Docket Item # 3 & 5
BAR CASE # 2009-0045 & 47

BAR Meeting
April 15, 2009

ISSUE: Alterations and a Waiver of HVAC screening requirement

LOCATION: 102 Gibbon Street

Figure 9. Proposed front elevation.

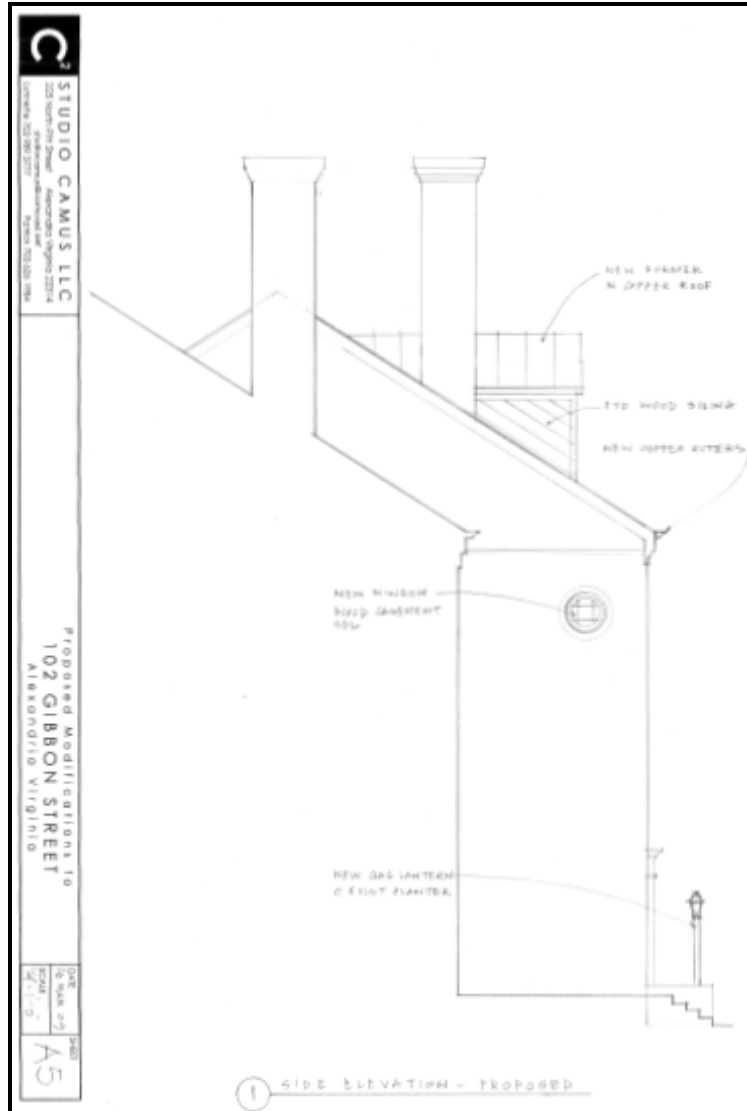
Staff does not support the installation of the single large dormer. The *Design Guidelines* note that “the style of the dormer should be appropriate to the architectural style of the existing structure.” This elevation of the townhouse is highly visible from both South Lee and South Union Streets and the park across Gibbon Street. While the BAR has approved rear dormers in this development, there is no precedent for the removal of the front dormers and the installation of a larger dormer. Staff believes it would significantly alter the front facade of this Colonial Revival style townhouse. Additionally, should the BAR approve this new dormer, it could result in additional requests for front dormers which would begin to create a piecemeal effect not unlike the development near Princess and North Union Street. In the opinion of Staff, Pommander Square retains a high degree of design integrity from when the Board first approved the development in 1971.

Staff does not support the use of faux slate shingles on the roof because it introduces a third roof material in the Pommander Square development. Staff suggests that the applicant use either asphalt shingles or standing seam metal, both of which have been used in the development.

1. That the window muntins be wood and not aluminum clad;
2. That the roof be clad with either asphalt shingles or standing seam metal and not faux slate;
3. That the proposed new dormer be deleted and that the two existing dormers be retained; and,
4. That the waiver of the rooftop screening be denied and that the rooftop well be deleted, and the HVAC units be located on the ground.

Figure 10. Proposed east elevation.

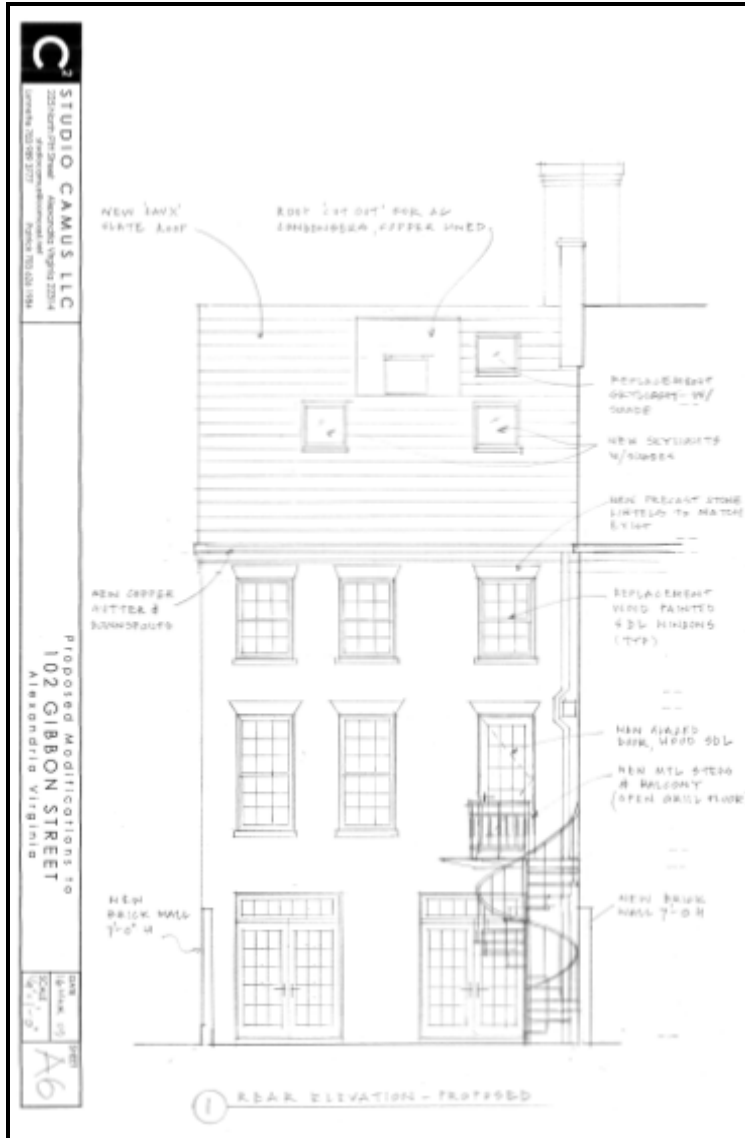
Because the oculus window proposed by the applicant is located on the shared property line, the applicant may be required to seek approval from Code Administration to allow its installation. Staff does not object to the installation of the window, if it permitted by Code Administration.

Figure 11. Proposed rear elevation.

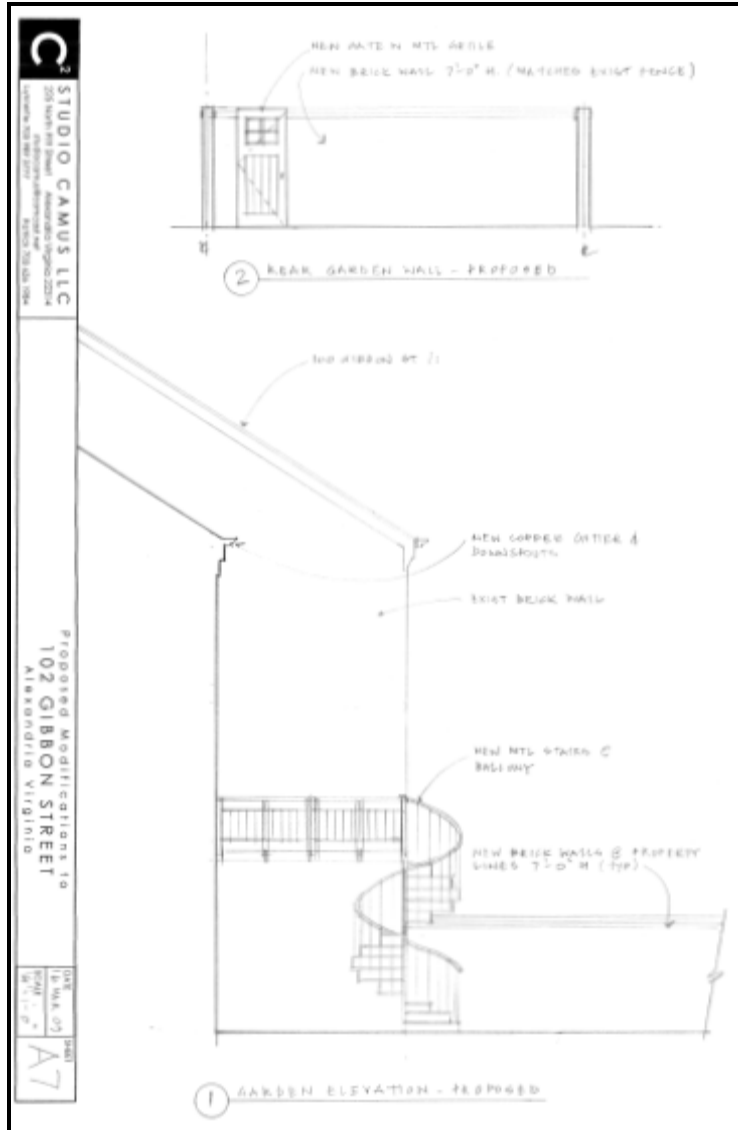
Staff also does not support the construction of the rooftop well on the rear slope of the roof. The proposed well is rather large in size and Staff believes it will be visible from South Union Street. Staff could locate only one other rooftop HVAC unit installed within the development but could find no record of BAR approval. Should the Board recommend approval of this HVAC well, Staff recommends that the applicant find a way to screen the units to diminish their visibility.
